RE: Petition No. 1058
1990 Line Structure Replacement Project
Amendment - *Modifications to Add Structure Lighting Per FAA Determinations*

On June 13, 2013, The Connecticut Light and Power Company (now doing business as Eversource Energy or Eversource) received a Declaratory Ruling from the Connecticut Siting Council (Council) that a Certificate of Environmental Compatibility and Public Need would not be required for the proposed 1990 Line (now re-designated the 1340 Line) Structure Replacement Project proposed in Petition No. 1058 (referred to herein as “the Project”).

Following construction of this Project, the Connecticut Airport Authority directed Eversource file requests for determinations with the Federal Aviation Administration (“FAA”) for additional structures on this line and the FAA subsequently issued determinations that the following structures would require lighting: structure 11167 in the Town of Oxford and structures 11168 and 11169 in the Town of Middlebury. These locations are highlighted as mark ups to the existing mapsheet of the Petition 1058 - Development and Management Plan (Attachment 2, Mapsheet 17 of 36). Specifically, Eversource proposes to install stead

Sheet 17 of 36

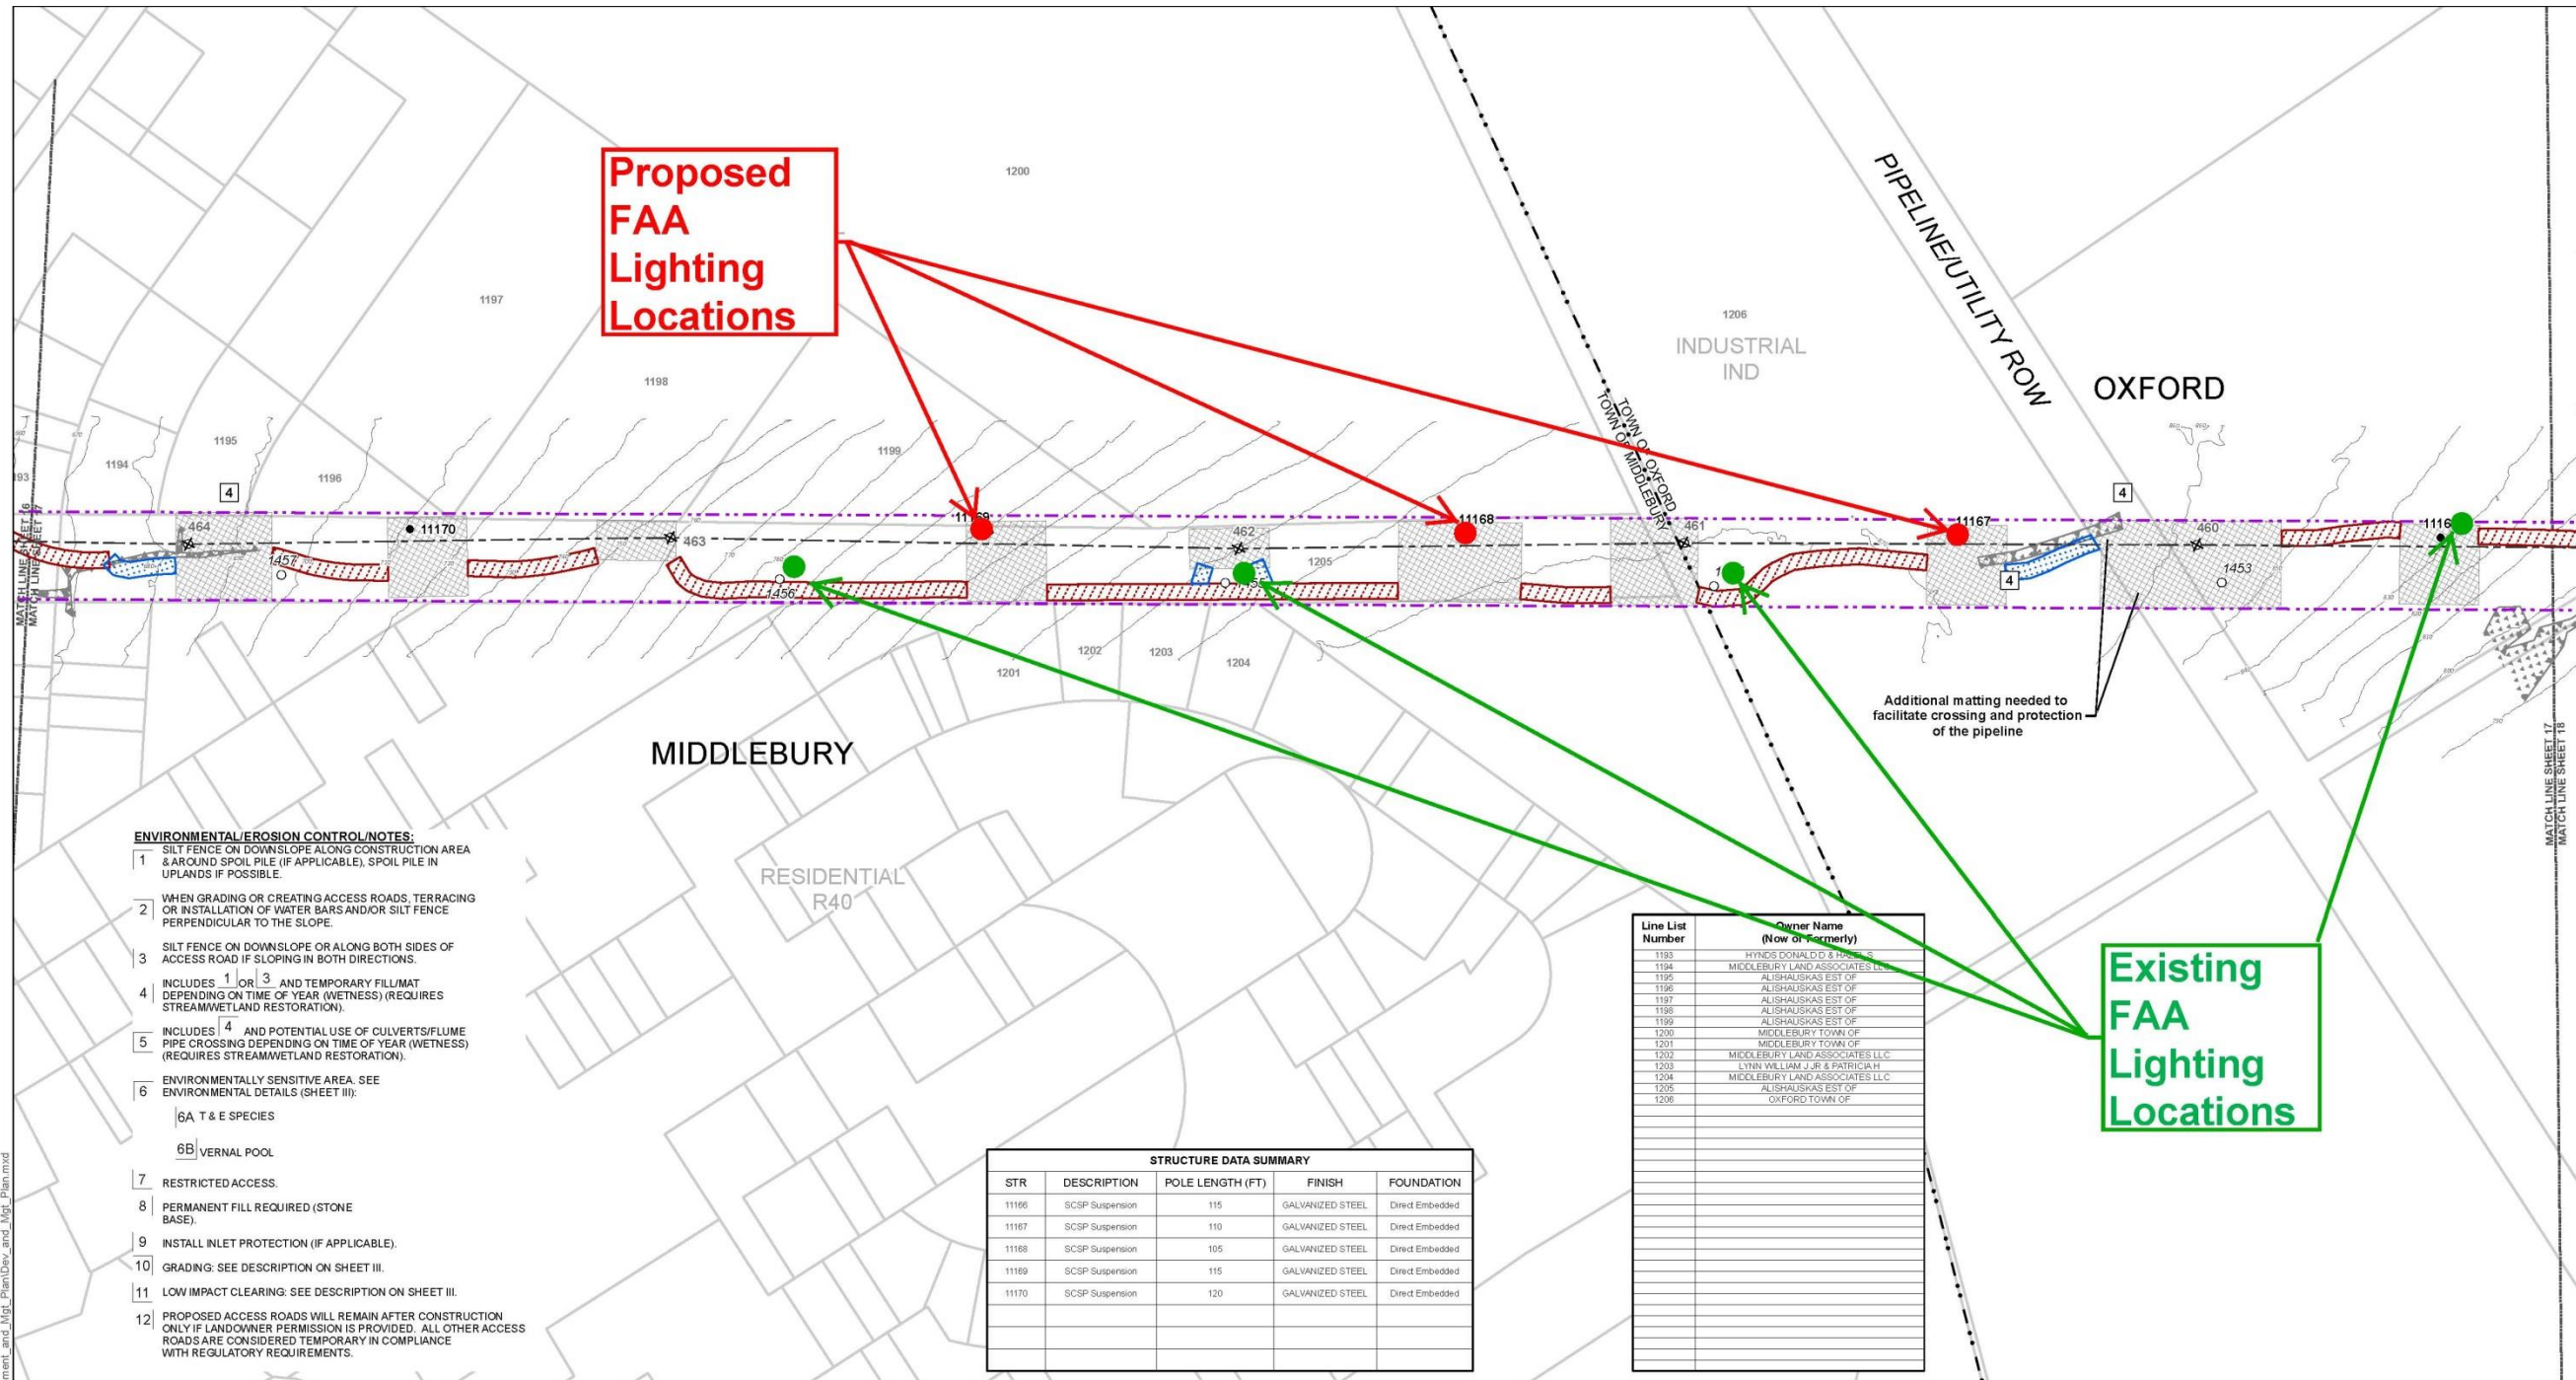
**Proposed
FAA
Lighting
Locations**

DETAIL A
OBSTRUCTION LIGHT LOCATION

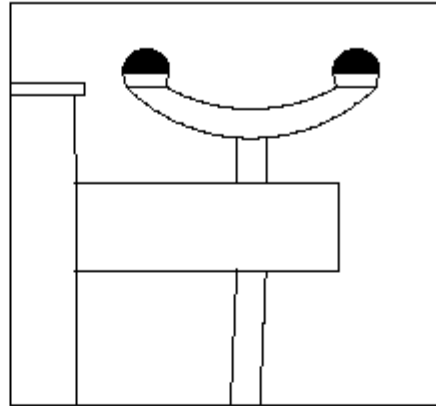
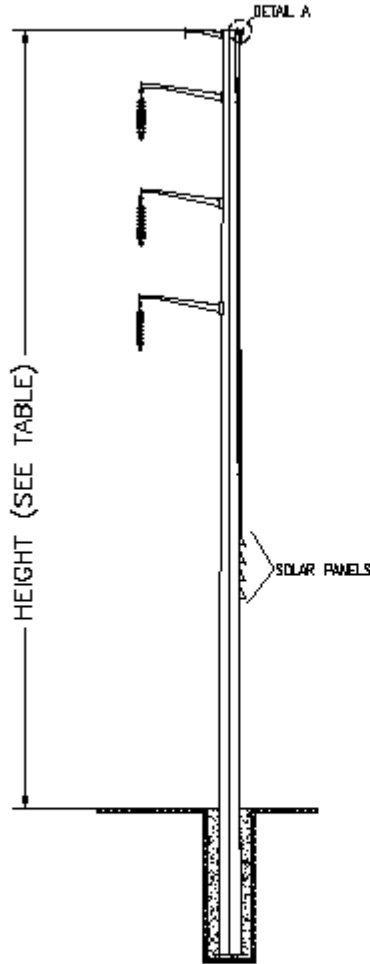
STRUCTURE CROSS SECTION DIAGRAM OF PROPOSED INSTALLATION

POLE HEIGHTS	
STRUCTURE #	HEIGHT
11167	93.5
11168	88.5
11169	98
